2000/SV-6
2000/ED-5

CHAPTER 343, HRS
Environmental Assessment (EA)/Determination
Finding of No Significant Impact

FINAL ENVIRONMENTAL ASSESSMENT FOR A

(SHORELINE SETBACK VARIANCE) '00 AUG 29 PM 10 11

1967 Aerial Photo 17

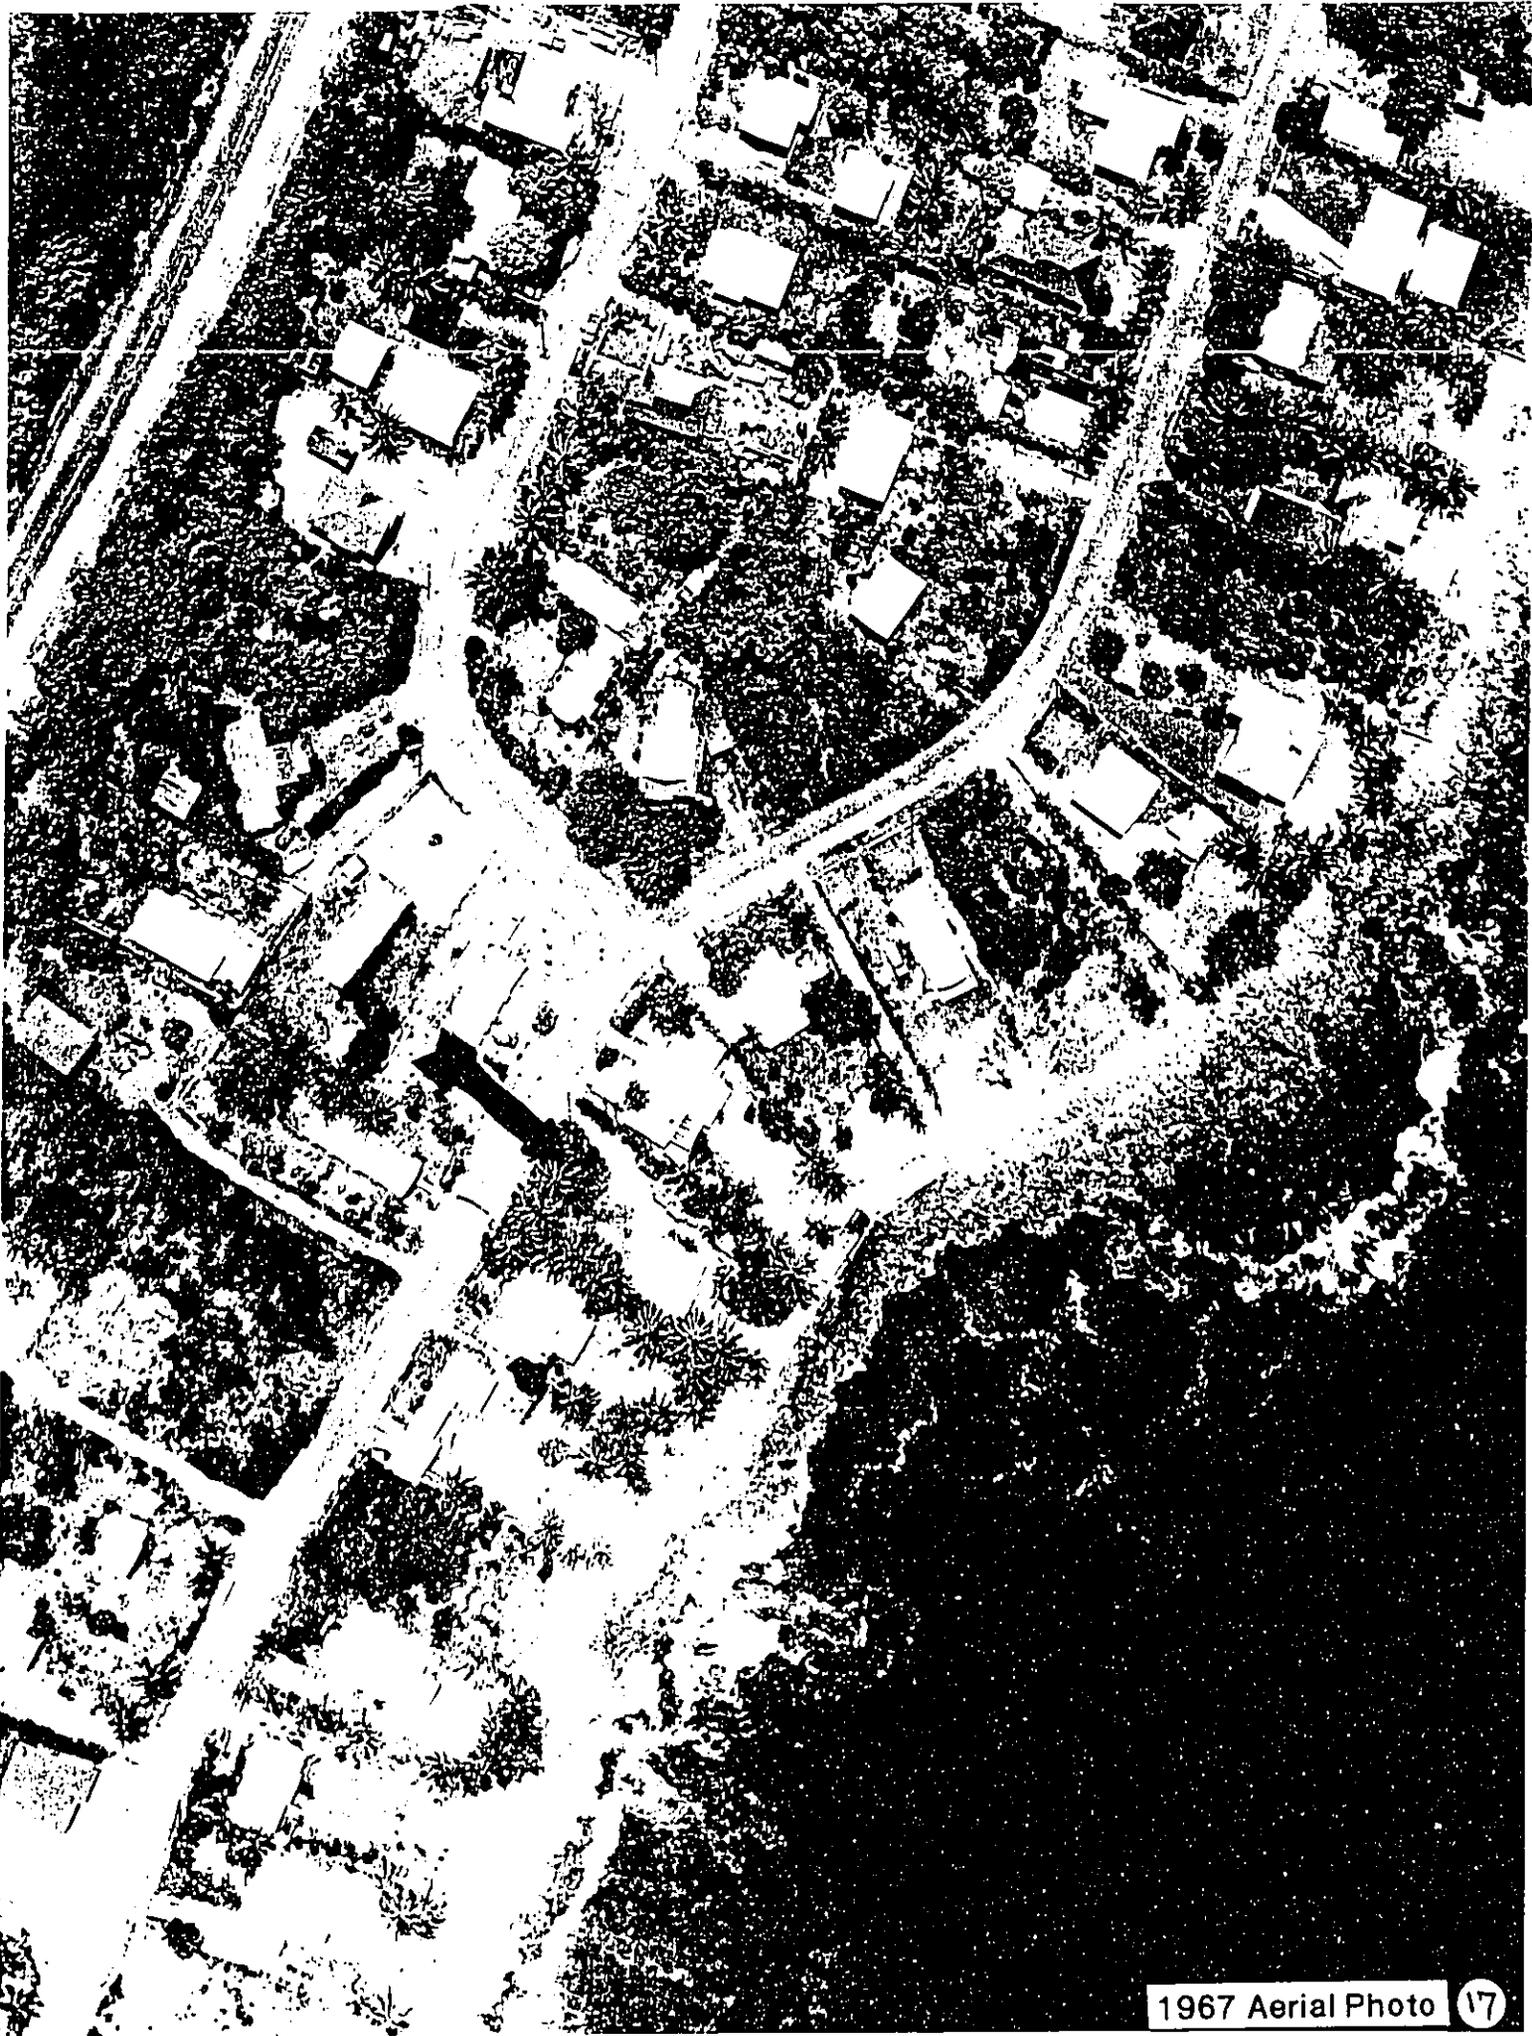
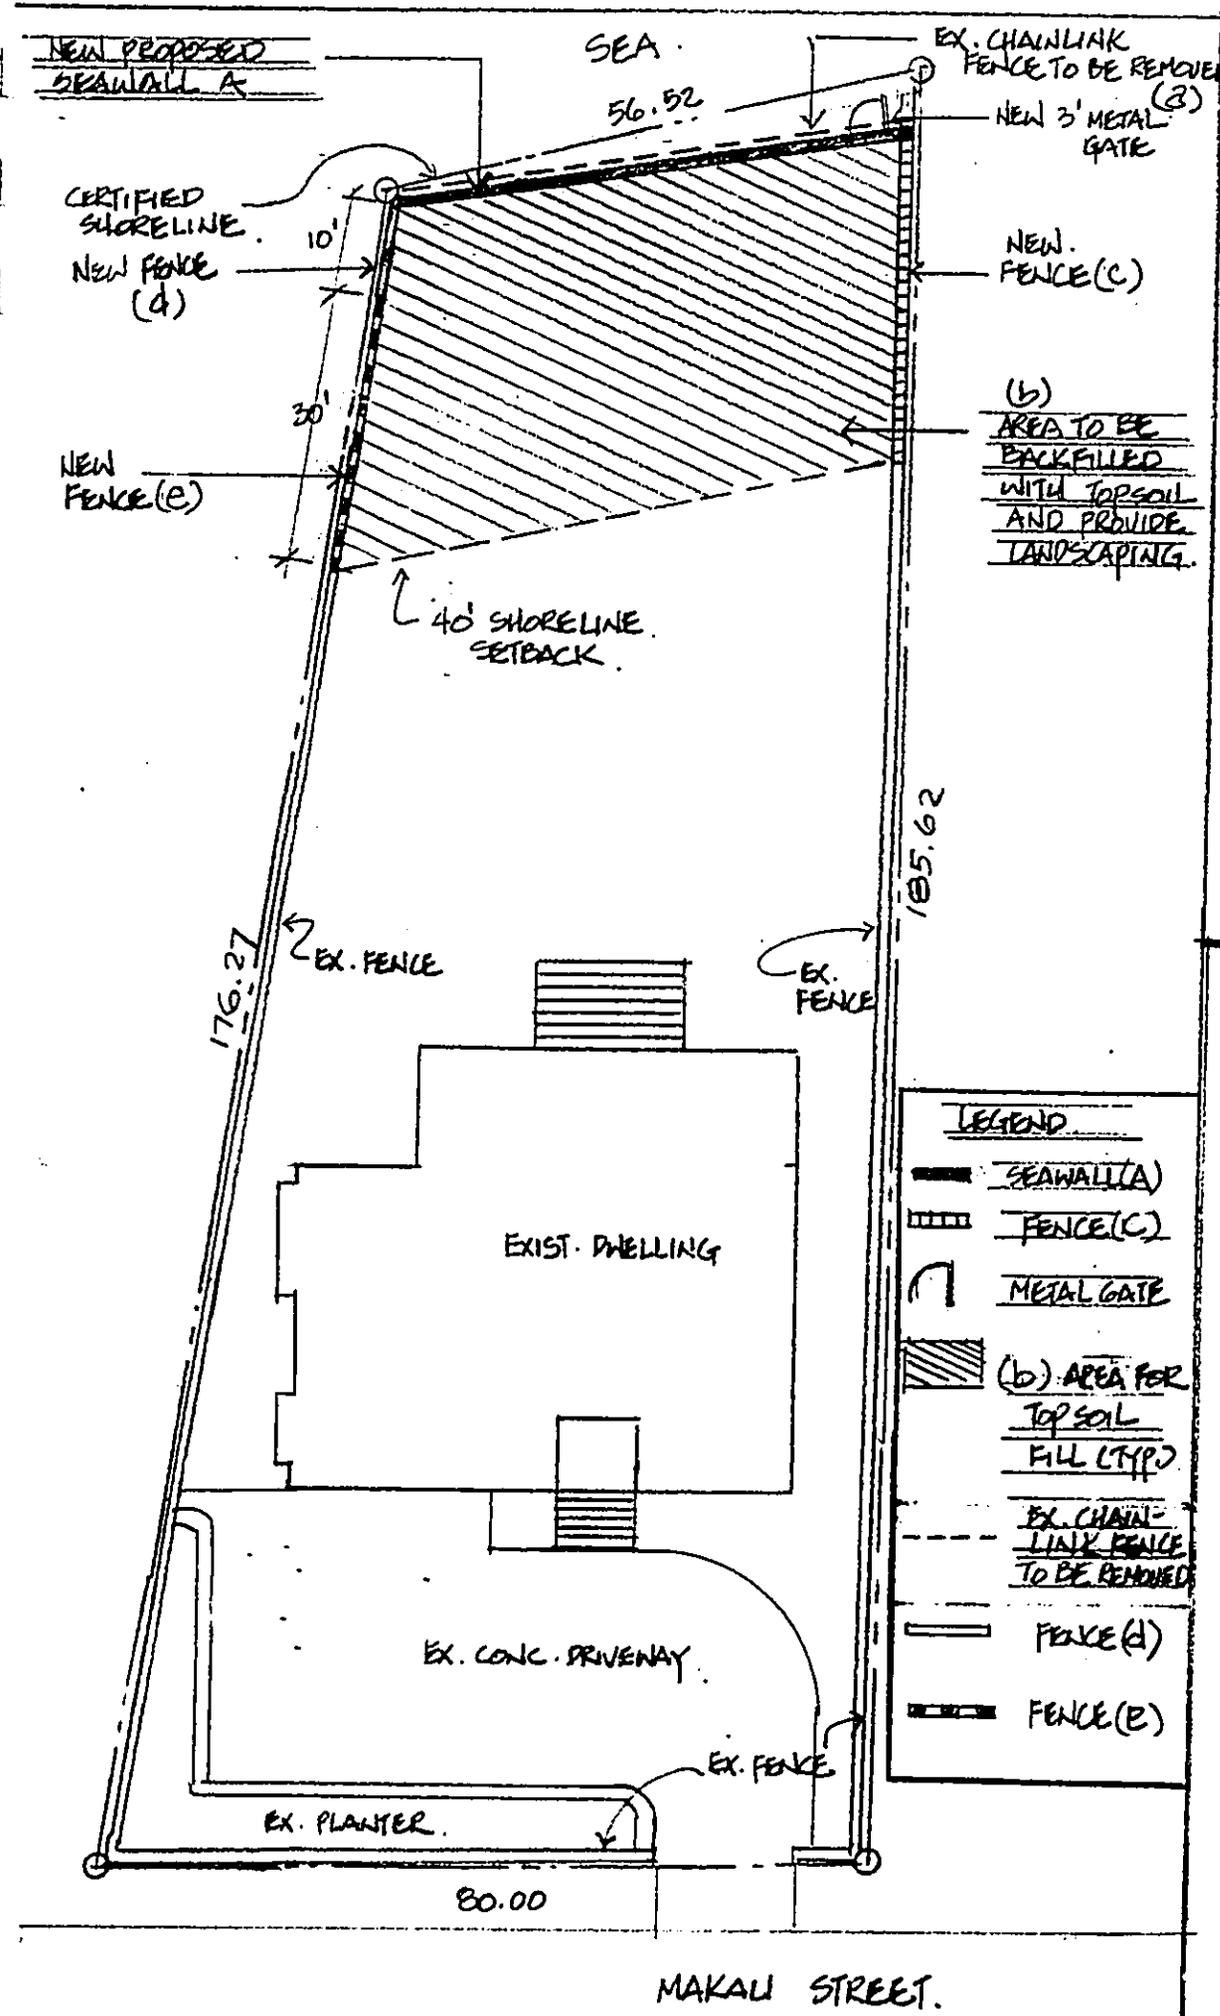
Pages 3 and 7 indicate that during high tides or surf, ocean waves wash through the chain link fence over the makai portion of the property. This condition is clearly shown in photos 8, 9 and 17. We note, however, that the shoreline survey seems to indicate that the shoreline is further seaward. The FEA should include a site plan identifying the location of the vegetation line.

RESPONSE: The certified shoreline has been determined by a licensed surveyor, and certified by the State, to be at the makai end of the property as shown on Exhibit 1, identified as the "upper reaches of the wash of waves". The vegetation line shown in photo's 8 and 9 is grass planted by the owner above the shoreline setback in top soil imported by the owner. The grass is growing makai into the more sandy shoreline setback area. Thus, the "vegetation line" shown in the photographs is not a result of wave action and is not a determiner of the shoreline. In fact, there is no vegetation line at this shoreline location.

Photos 13-17, show wave action resulting from offshore storms and covering the lava outcropping. The effect is greater when storm surges occur during high tides. The photos show the potential impact of these waves on the property and why a wall is needed.
